Number: SB2X-76-05**Issued: 29 Oct 2024**

SNS SUBJECT: 76-10 POWER CONTROL - Upper Power Lever Inspection and Replacement

Figure 02
Dye Penetrant Inspection Example

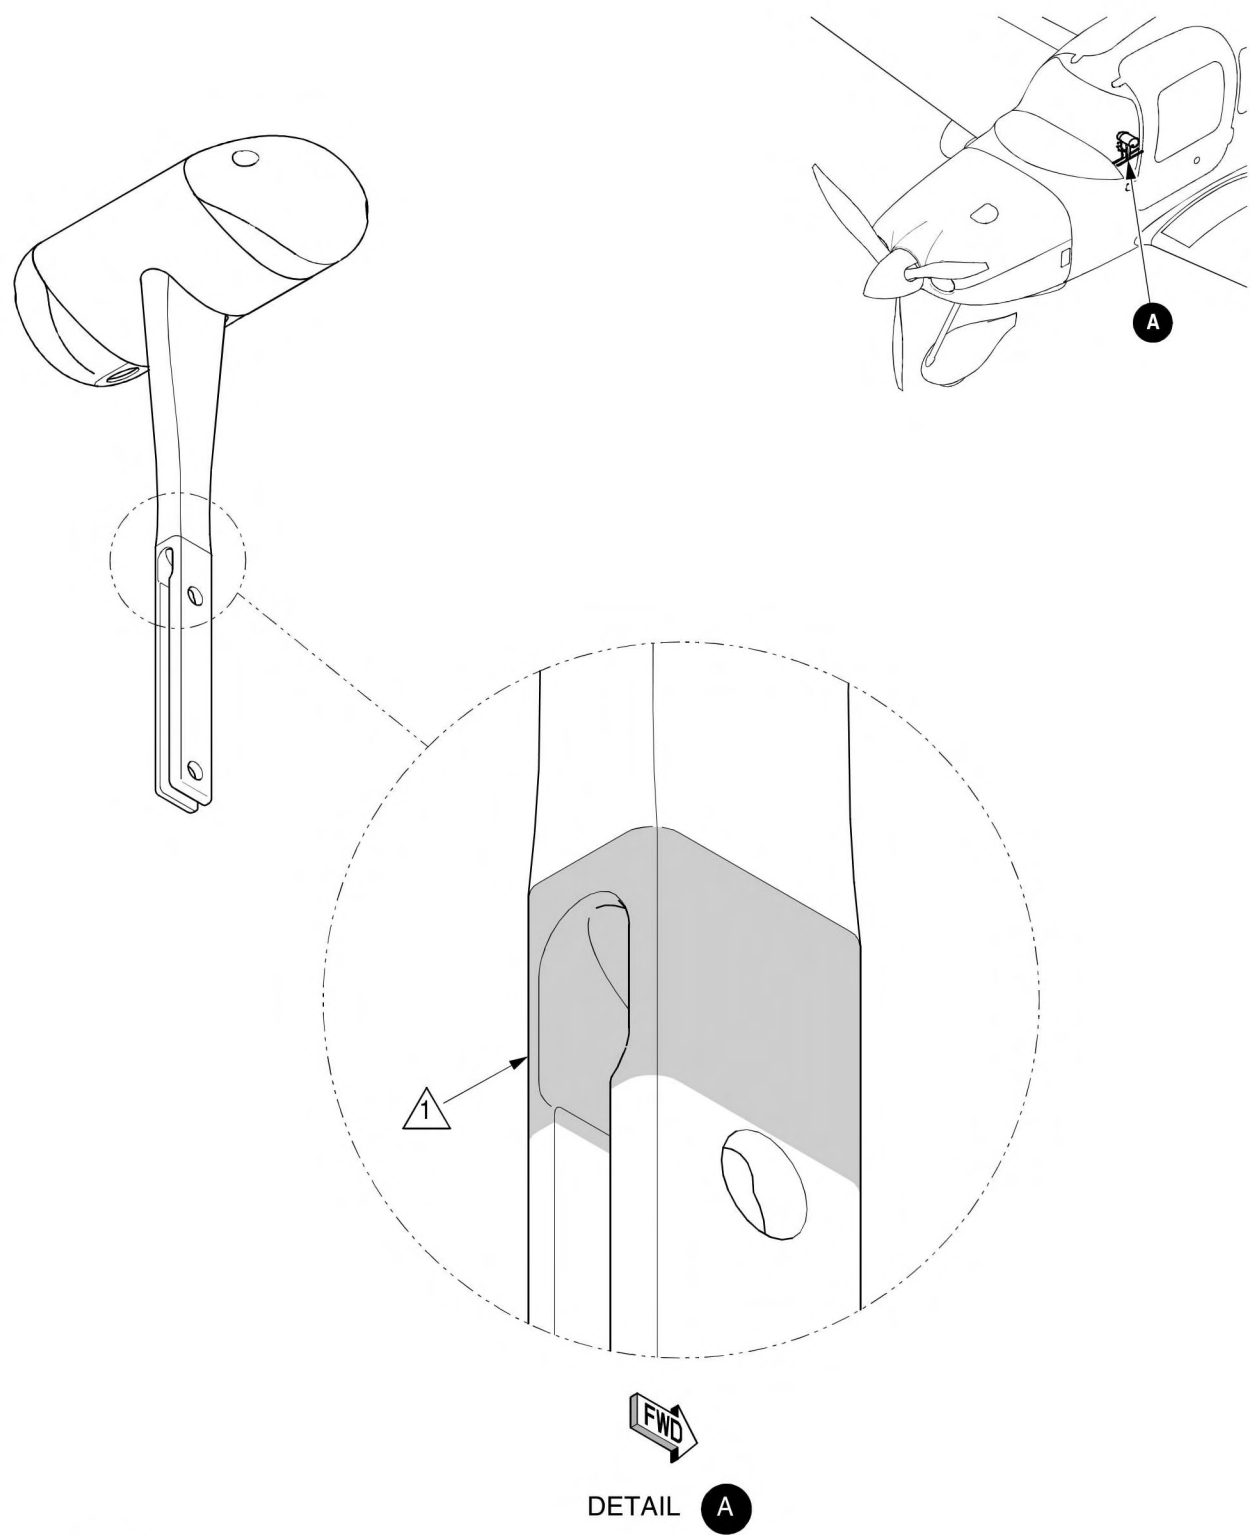
- J. Allow developer to dwell for 10 minutes minimum. (See Figure 02)
- (1) If cracks are detected, return damaged component to Cirrus for analysis. Install new upper power lever (item 1). (Refer to AMM 76-10)

1. Positive identification of surface crack.
2. Positive identification of interior crack.
3. Sample of minor scuffing, not applicable.

- (2) If no cracks are detected, install existing upper power lever. (Refer to AMM 76-10)
- K. Visually inspect engine side stops (bolts) of throttle cable assembly for bending. If bent, remove and replace according to engine manufacturer's maintenance manual.

Figure 01
Upper Power Lever Inspection Area

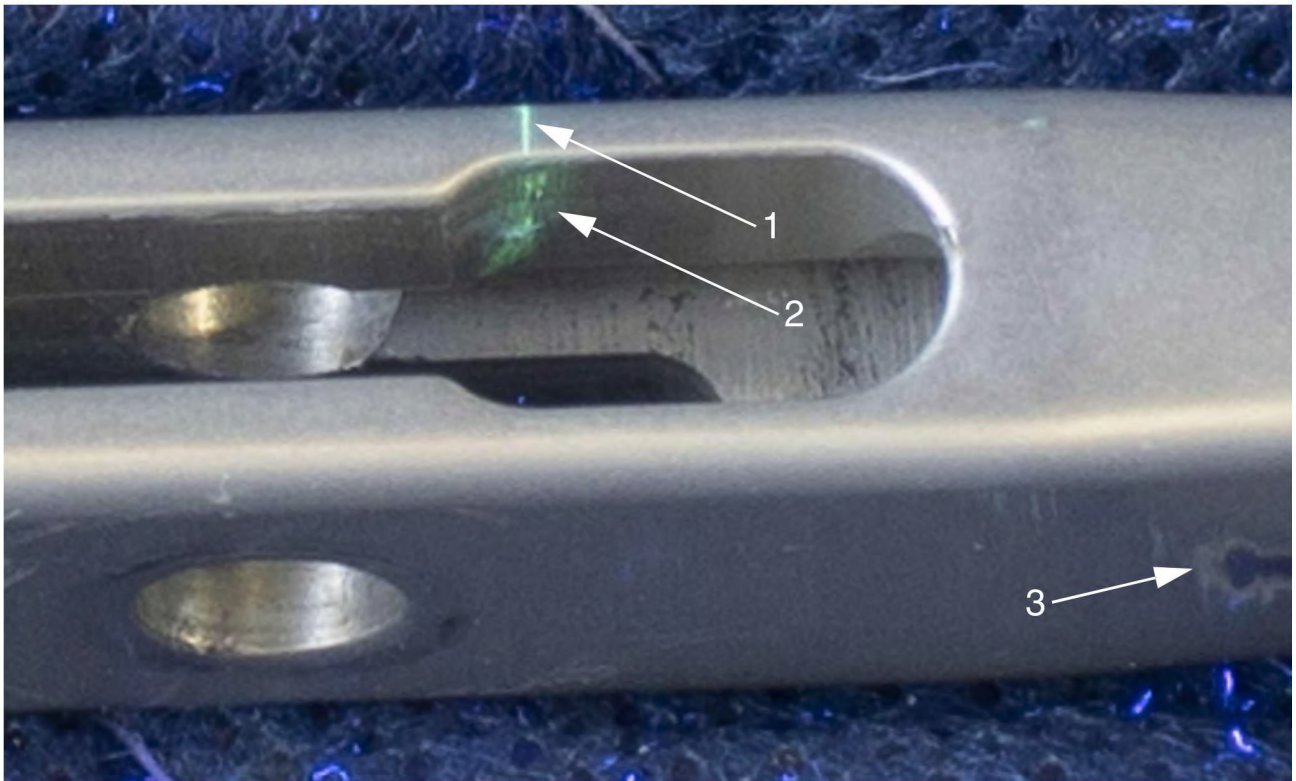
F. Use magnifier to visually inspect upper power lever for damage. (See Figure 01)

NOTE
1 Inspect shaded area for damage. Minor scratching/scuffing is acceptable.

(1) If cracks are detected, no further inspection is required. Return damaged component to Cirrus for analysis. Install new upper power lever (item 1). (Refer to AMM 76-10)
